APRIL, 1991

BULLETIN.008

## WELDARC 140: MC84    WELDARC 12P: MC85 MC84-11 PCB CALIBRATION

WELDING INDUSTRIES OF AUSTRALIA	
				112 Daws Road, Melrose Park, S.A.5039	
				TITLE	
				P.C.BOARD ASSEMBLY	
B	10/7/90	gc	RESISTOR VALUES R8 & R9 CHANGED C/N 1054	DRAWN	DRAWING No.
A			ISSUE FOR MANUFACTURE	M.W.	
ISSUE	DATE	CHKD.	REVISION	DATE	
				6-7-90	MC84-11

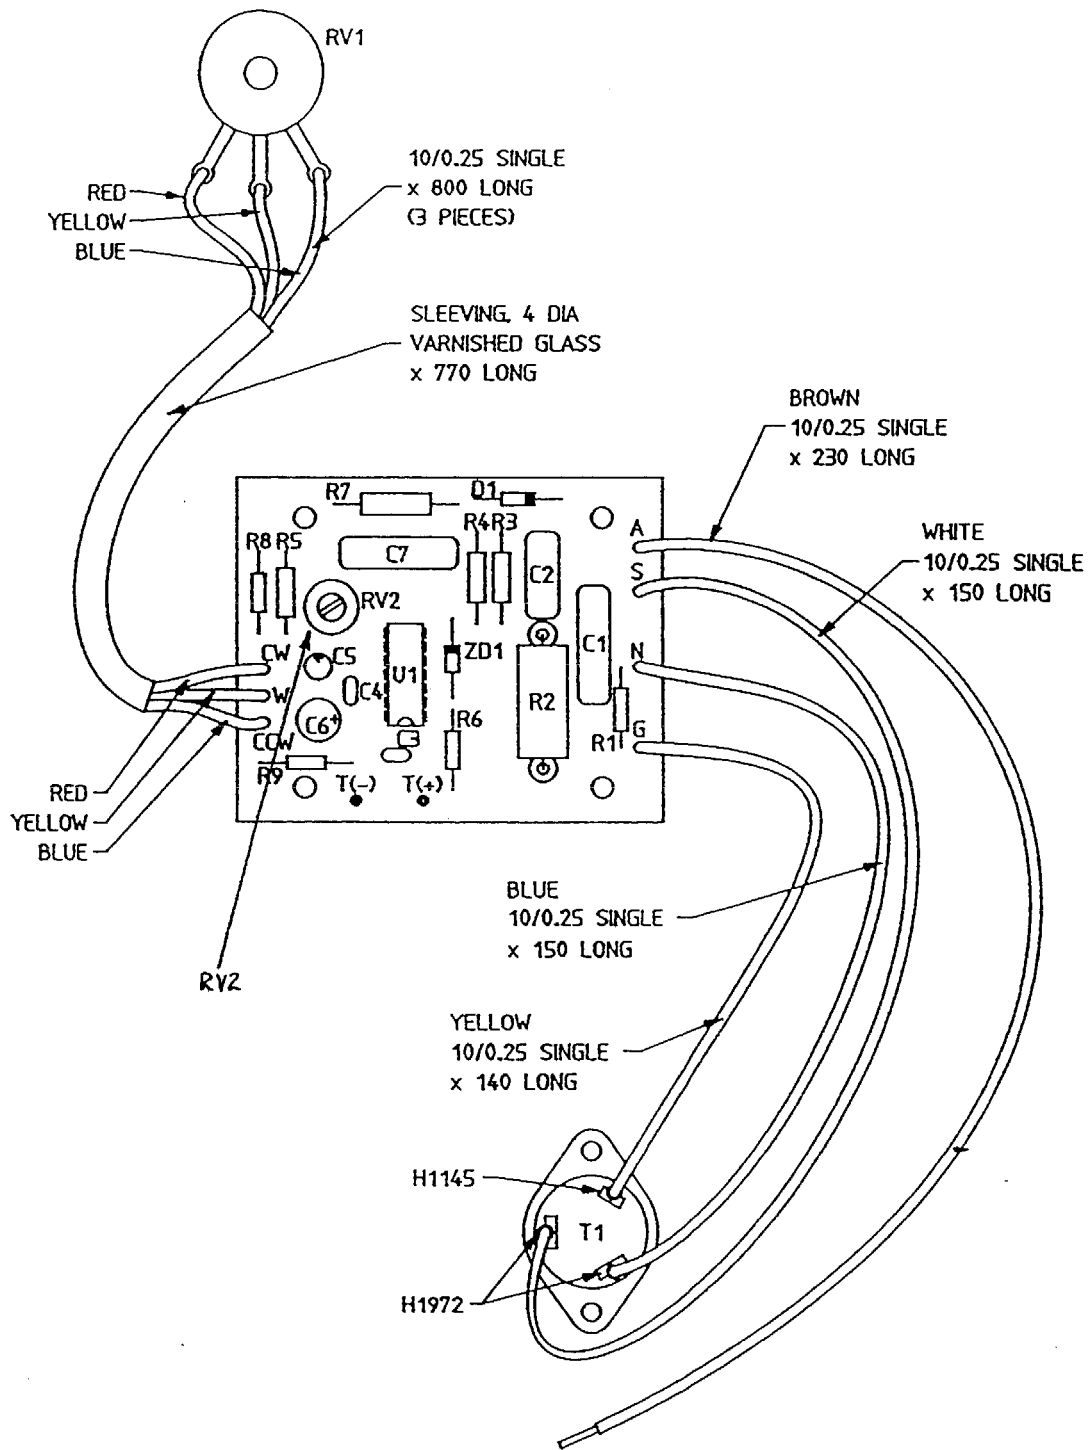
When the MC84-11 PCB is replaced in a machine, the new assembly must be calibrated to set the phase shift range.

For the MC84 Weldarc 140, or MC85 Weldarc 12P, with the Current Control knob set to minimum, adjust RV2 so that the open-circuit voltage is as close to 40Vac as possible.

Apply a small amount of contact glue or thick paint to the 'skirt' of the potentiometer to secure the adjustment.
